A-5-LGB-22-0025 (GRAY)
April 12, 2023

EXHIBITS

Exhibit 5 – Bluff Edge and Geologic Setback Review Memorandum

REVISED BLUFF EDGE & GEOLOGIC REVIEW MEMORANDUM

Figure 1 – Geologic Site Plan with LUE Bluff Edge and 25-ft Setback

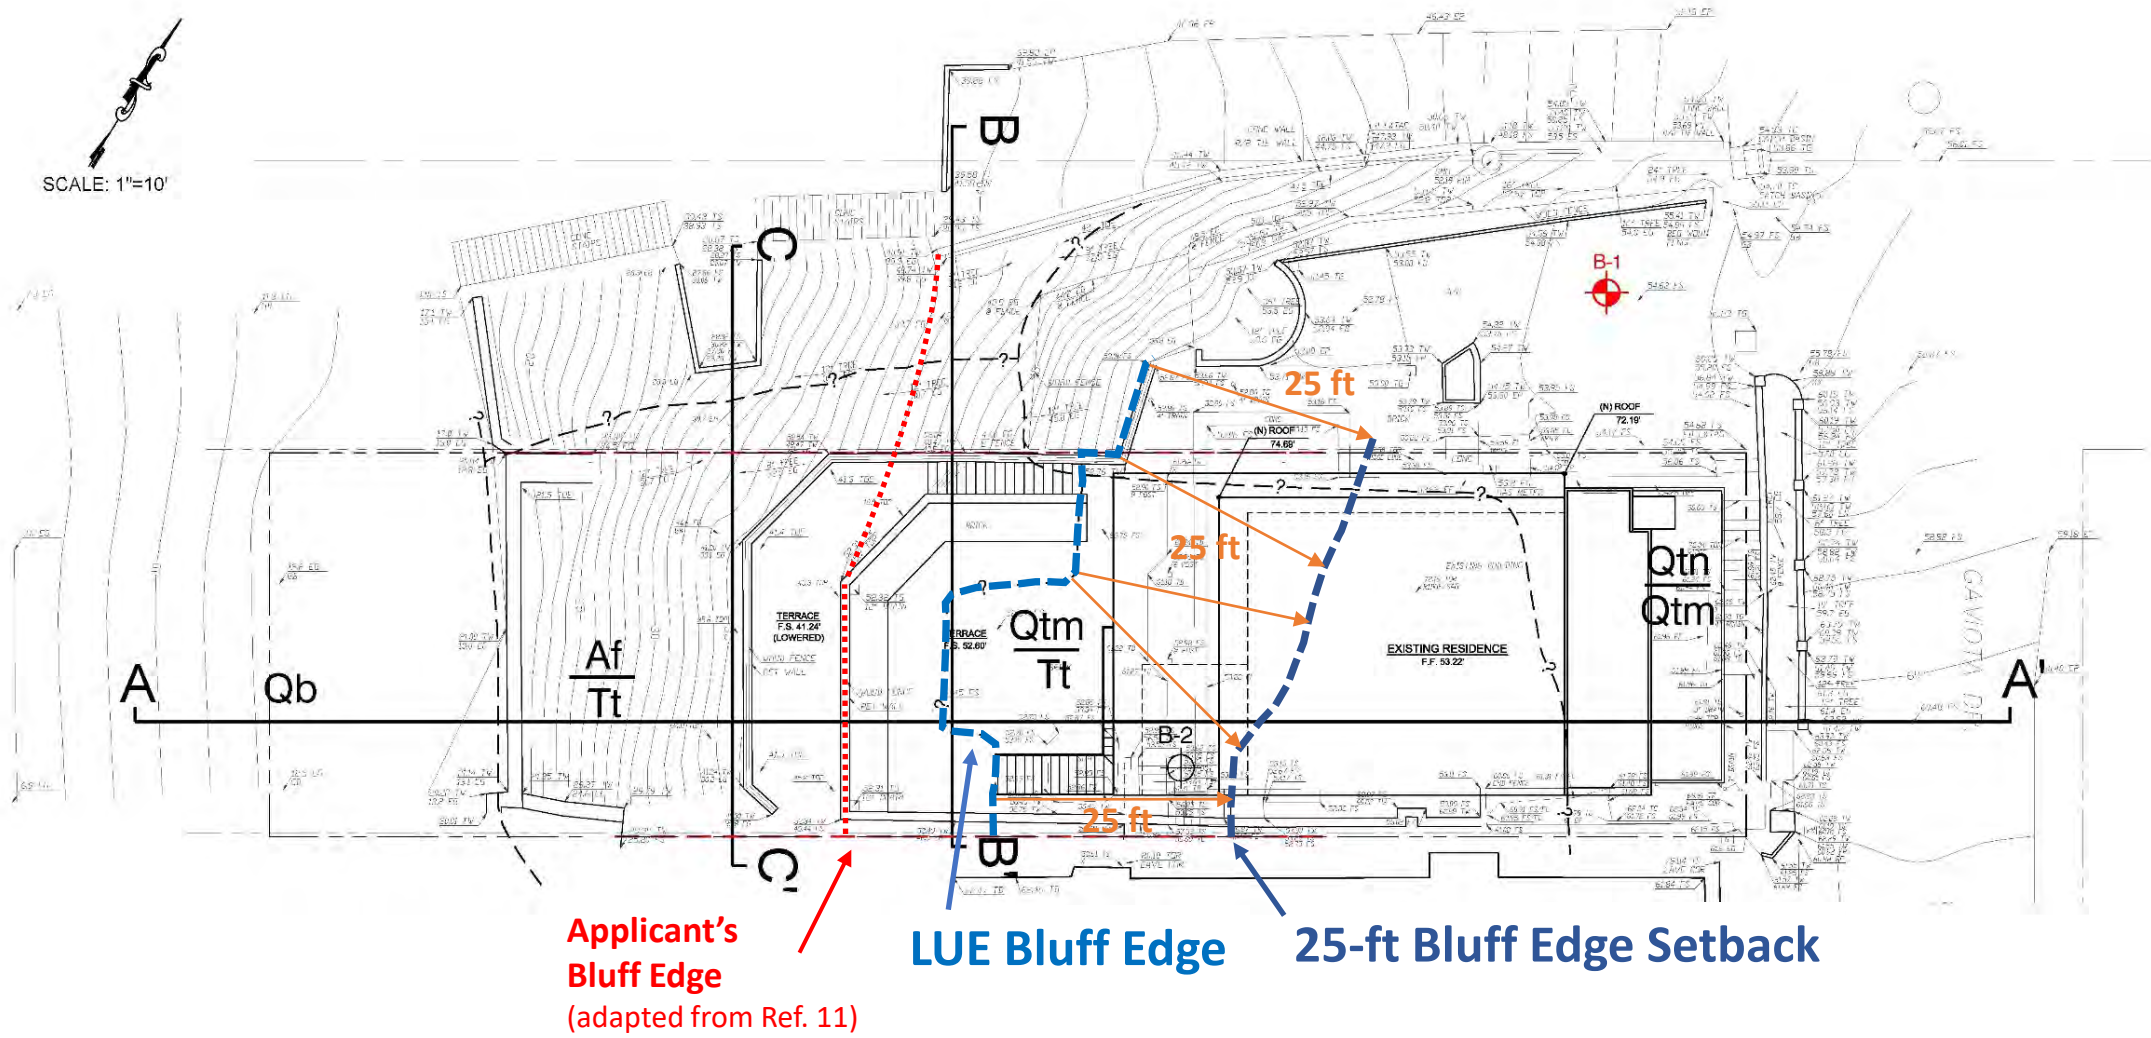
The City LCP requires a minimum 25-foot development setback from the bluff edge for new principal development. As shown in Fig. 1, a 25-ft setback from the LUE bluff edge, would result in larger setbacks – on the order of 40 – 50 feet from the top of the existing fill slope (i.e., top of the upper retaining wall), which extends seaward of the natural bluff face, across most of the subject lot. The 40 – 50-foot geologic setbacks that would result from applying the default 25-foot *bluff edge* setback³ would provide a substantial buffer against future increases in the bluff erosion rate due to SLR. For these reasons, I believe that a development setback of 25 feet from the coastal bluff edge, as defined in the City's certified LUE and illustrated in Fig. 1, is likely to ensure the safety and stability of new development at the site over a 75-year economic life, without reliance on shoreline protection. However, given the uncertainties involved, it would still be prudent to include special conditions to further minimize hazards, such as a deed restriction and assumption of risk provision to make the permittee and future owners aware of the hazards inherent to this location, and a requirement that the new development be removed or relocated if it is threatened by erosion in the future.

³ These relatively large distances result in part from measuring the 25-ft setback from all points and at all angles on the irregular bluff edge line (see Fig. 1).

Figure 2: Site Cross-Section (A-A')

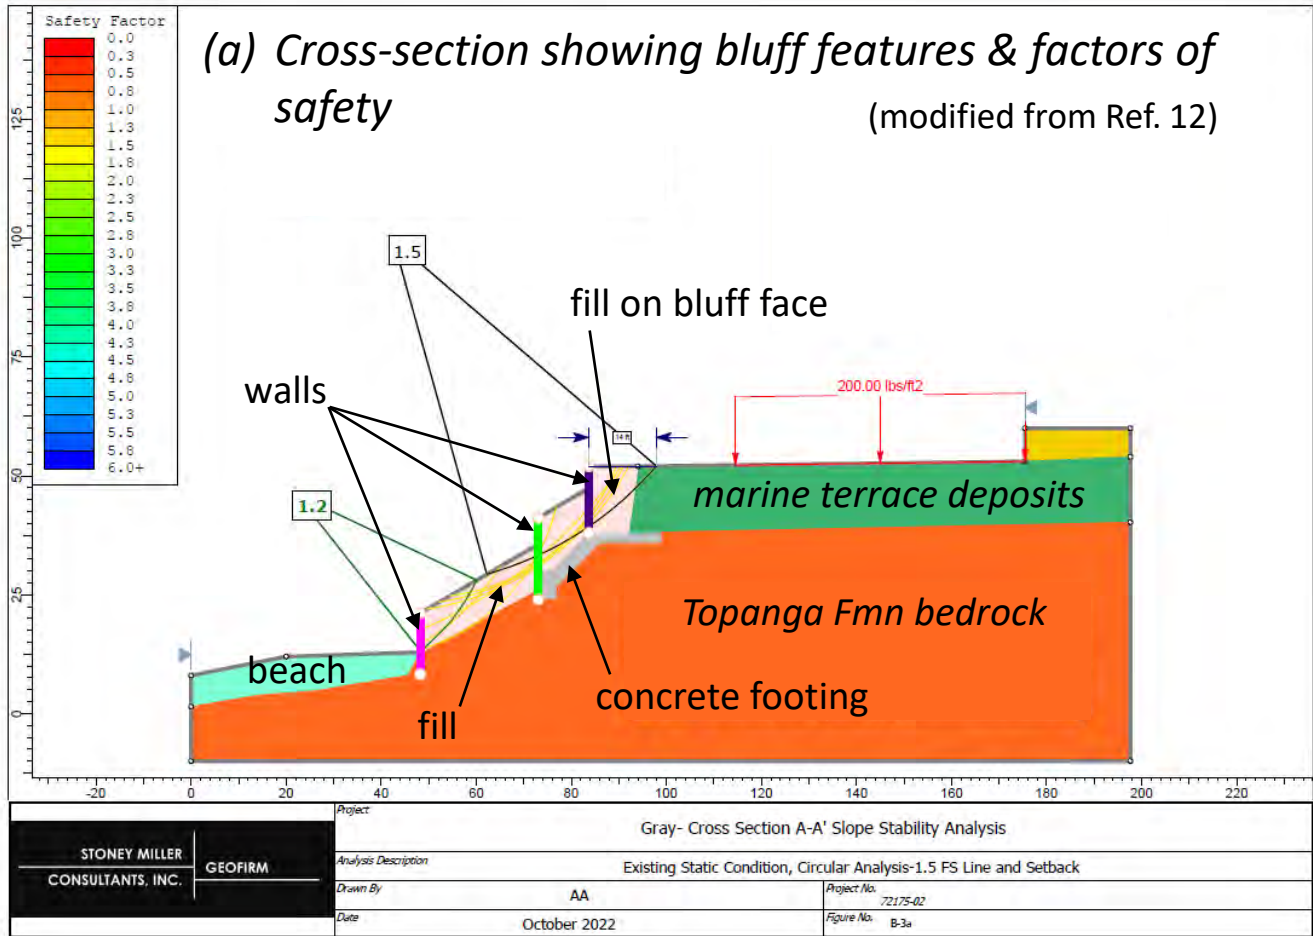
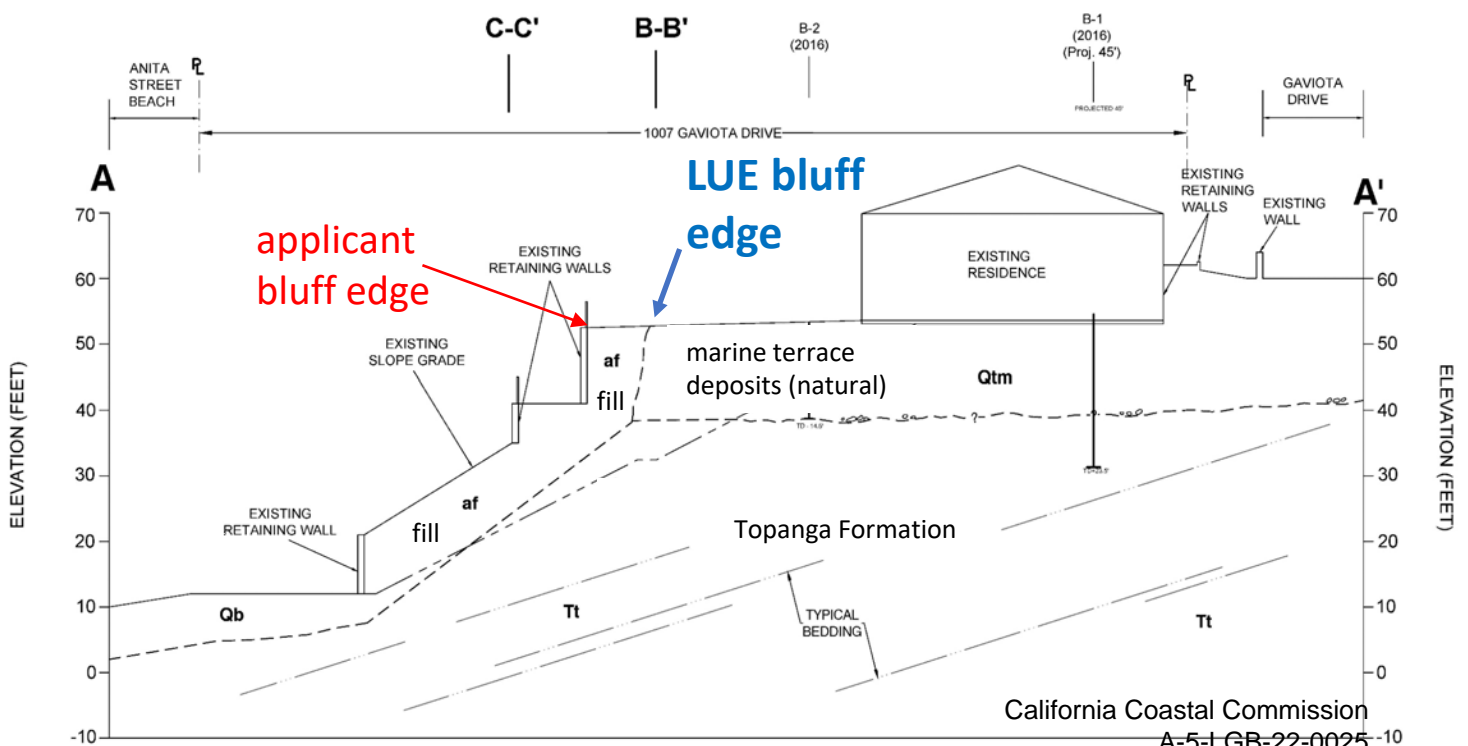
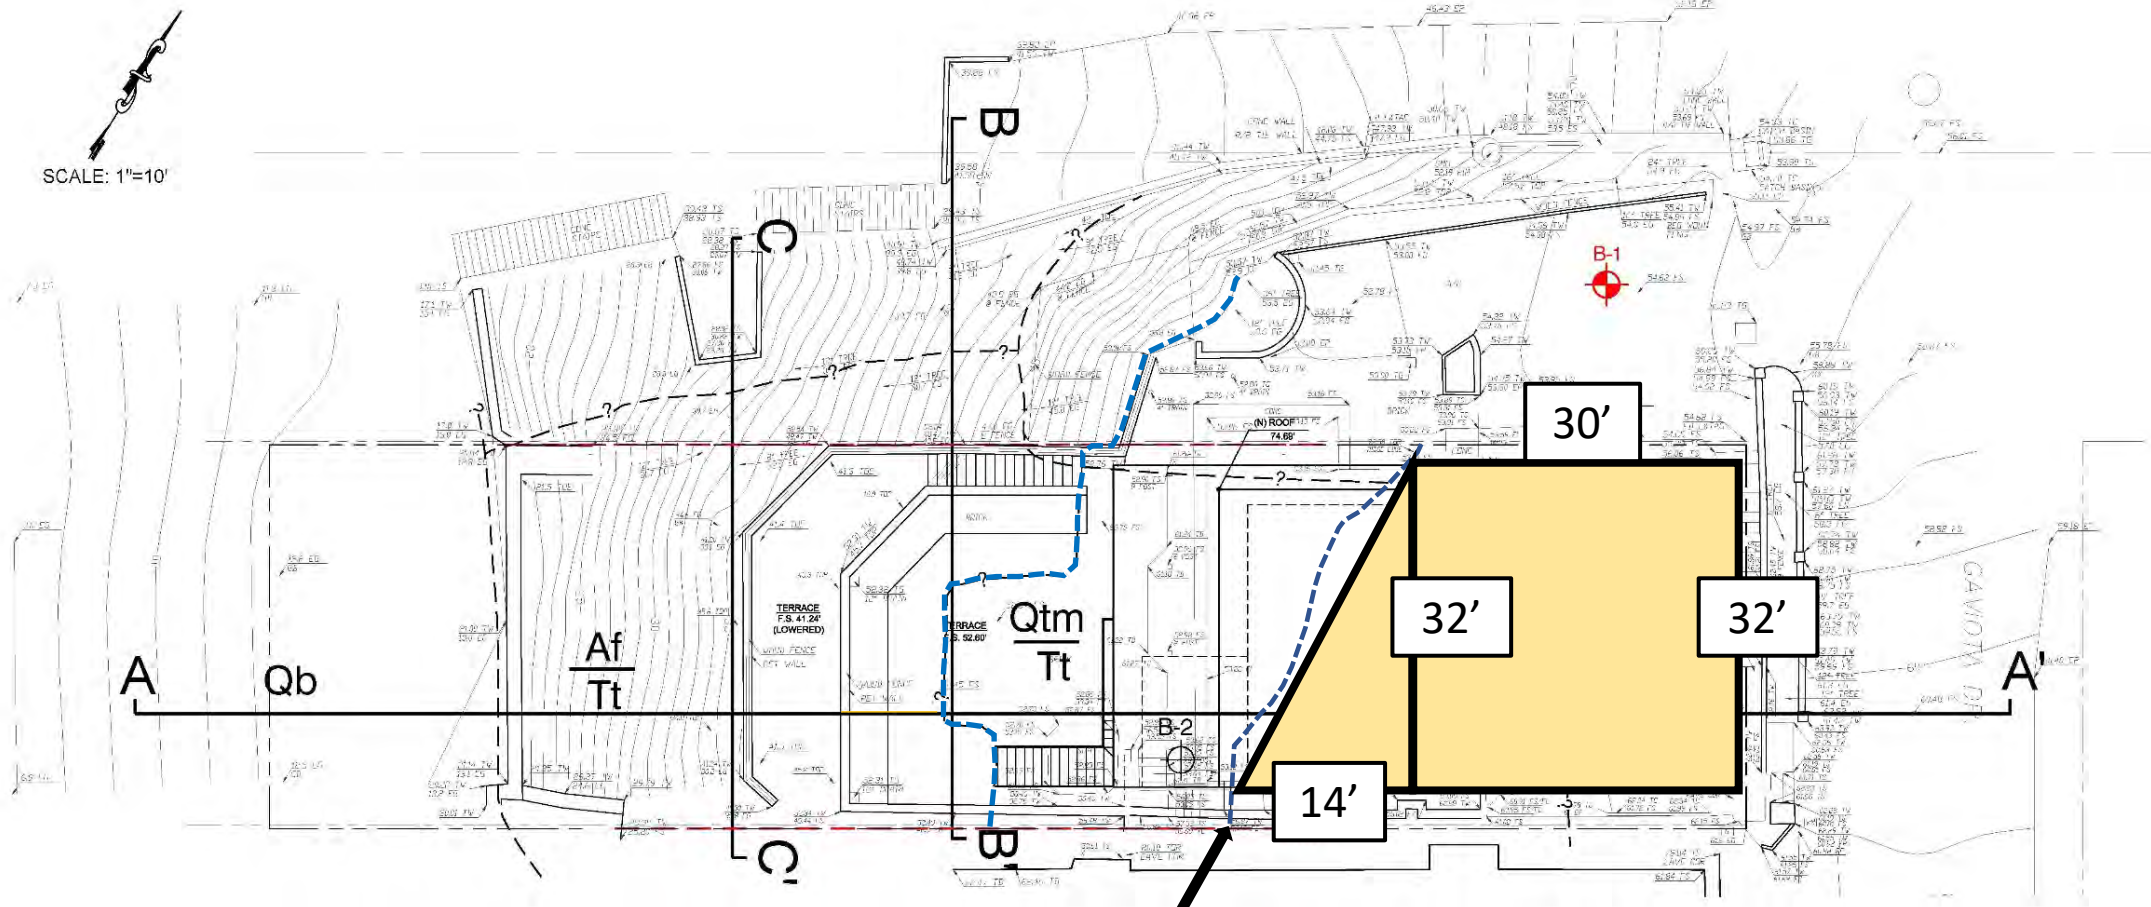
The use of greater along-bedding shear strength values for the Topanga Formation rock appears to be justified by prior data, indicating that the revised slope stability analysis is valid. However, it is worth noting that though the retaining wall system was excluded from the analysis, the buried concrete fill that provides foundation support for the walls was not, and thus the analysis may not represent a completely "unprotected" bluff condition. This concrete fill is integrated into the existing bluff face and could not be removed without significant excavation and damage to the natural bluff, and in my view the revised analysis in Ref. 12 provides a reasonably realistic snapshot of bluff stability if the primary protective structures – the exterior walls -- were absent.
